Access Compliance Report

Public Rights-of-Way

(Curb Ramps)

Intersection ID: 42495	Main Street: ALMA_BLOUNT_BV	Cross Street: TOLLESON_AV	Location: NW
ADA ID: 5B6AA16BDDA9	Ramp Type: Combination1Diag	Initial Pass/Fail: Fail	Overall Compliance: No
		Severity Score: 0

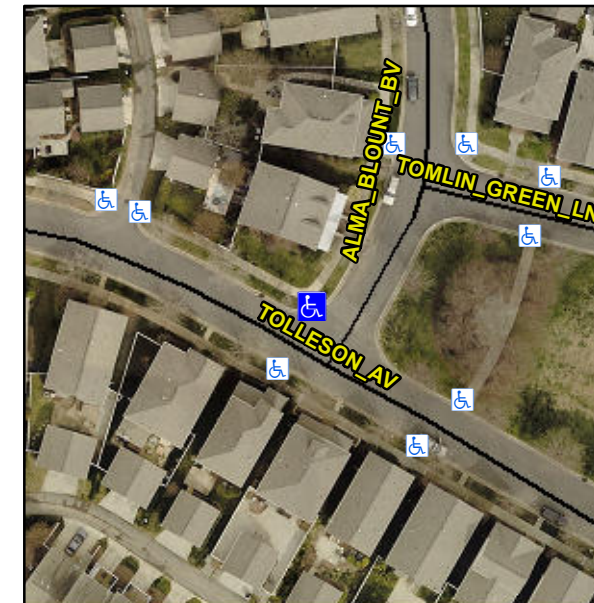
LT RP < 5%

R304.5.1, R304.5.3

Remove & Replace Curb Ramp With Two New Directional Ramps or Equivalent.
